- A. Incorrect Matching of Quicksilver Rotary Head and Steering Mounts
- B. Locking Sleeve C-71669A1 - Use with MerCruiser 110-thru-470 Power Steering Systems

Figure 1. Typical Power Steering Cylinder and Valve Assembly

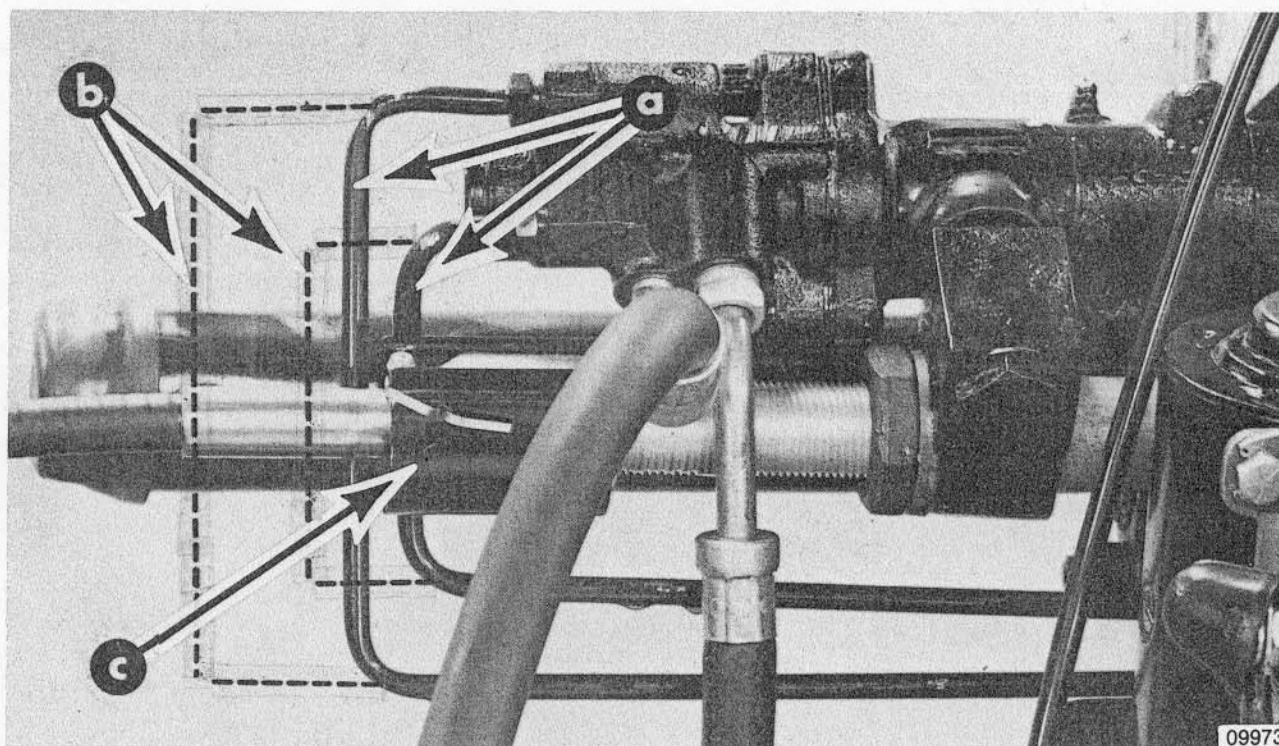
When installing Locking Sleeve C-71669A1 (Figure 1) on a Ride-Guide cable with MerCruiser Power Steering B-60501A1, B-71333A1 (MCM 110-thru-165) and B-76742A1 and A2 (MCM 470), interference may exist between the locking sleeve ("c" shown in Figure 1) and the short hydraulic tubes ("a"). With the above Power Steering Systems, it is necessary to replace the short hydraulic tubes with longer tubes (B-32-78895 and B-32-78896) before installing the locking sleeve.

a - Short Hydraulic Tubes b - Long Tube Location c - Locking Sleeve
